ACCESSION NBR: 8603200092 DOC. DATE: 86/03/14 NOTARIZED: YES DOCKET #
 FACIL: 50-410 Nine Mile Point Nuclear Station, Unit 2, Niagara Moha 05000410
 AUTH. NAME AUTHOR AFFILIATION
 MANGAN, C. V. Niagara Mohawk Power Corp.
 RECIP. NAME RECIPIENT AFFILIATION
 ADENSAM, E. G. BWR Project Directorate 3

SUBJECT: Forwards revised FSAR pages re QA program. Program will be fully effective for all QA activities upon completion of 100 h warranty run. Info will be incorporated into Amend 26 to FDSAR.

March 14, 1986
(NMP2L 0659)

Re: Nine Mile Point Unit 2
..Docket No. 50-410..

FIGURE 17.1-2

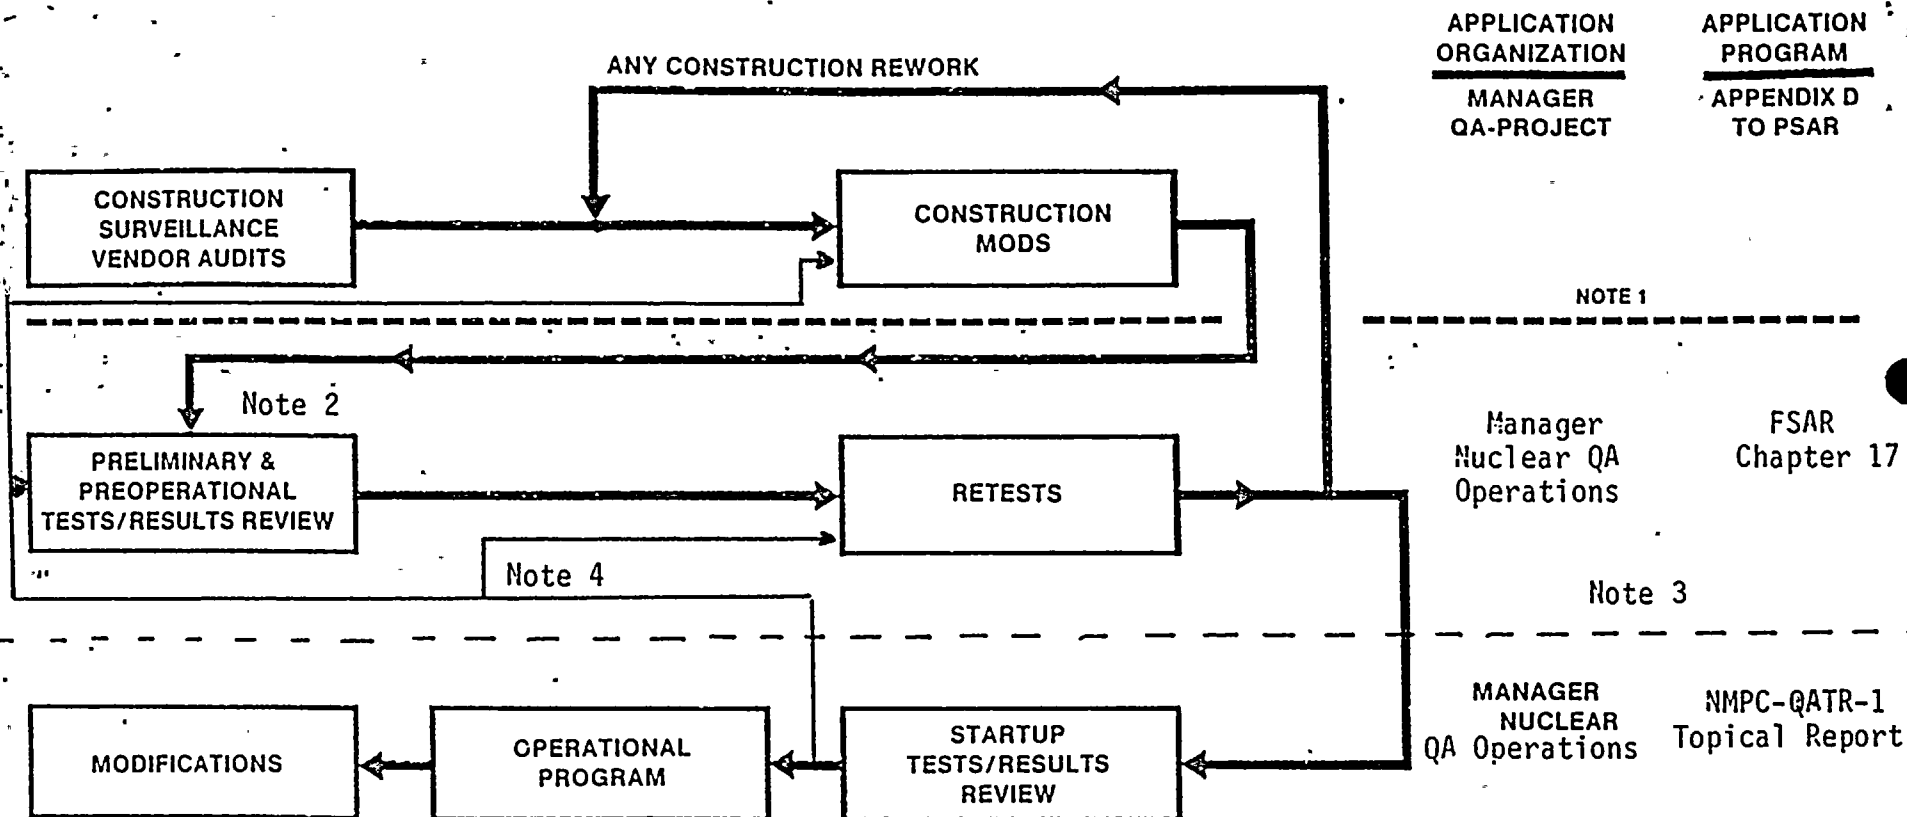
Appendix D to the Unit 2 PSAR, as updated in accordance with 10CFR50 submitted under separate cover, defines the NMPC QA program used for the design and construction phase of Unit 2. This section describes the QA program to be used during the preliminary and preoperational testing phase of NMP2 including those preoperational/acceptance tests and retests performed in the period starting with fuel load and ending with the 100 hour warranty run. Startup testing and operational activities subsequent to preoperational testing will be governed by the Niagara Mohawk Power Corporation Quality Assurance Program Topical Report Nine Mile Point Nuclear Station Units 1 and 2 Operations Phase, NMPC-QATR-1, Revision 1. Figures 17.1-1 and 17.1-2 depict the organizational structure and lines of responsibility for the three program phases. Figure 17.1-2 also shows that during the interval between fuel load and full power commercial operation, all three programs will be employed to handle any components or systems requiring reworking or retesting by the construction and preoperational test groups at NMP2. Following the 100 hour warranty run at full power, the PSAR Appendix B and FSAR Chapter 17 programs will be replaced by the NMPC-QATR-1, Revision 1, Topical QA program.

The QA Department is a corporate department under the direction of a Director of Quality Assurance (see Figure 17.1-1) who reports on quality matters to the President. Further definition of the administrative and functional organizations is included in the procedures developed to implement specific parts of this program. Table 17.1-1 contains tabular cross-references from 10CFR50 Appendix B to the applicable NMPC procedures. The QA Department regularly reviews the status and adequacy of the QA program, including a quality compliance review of all contractors and a self-appraisal.
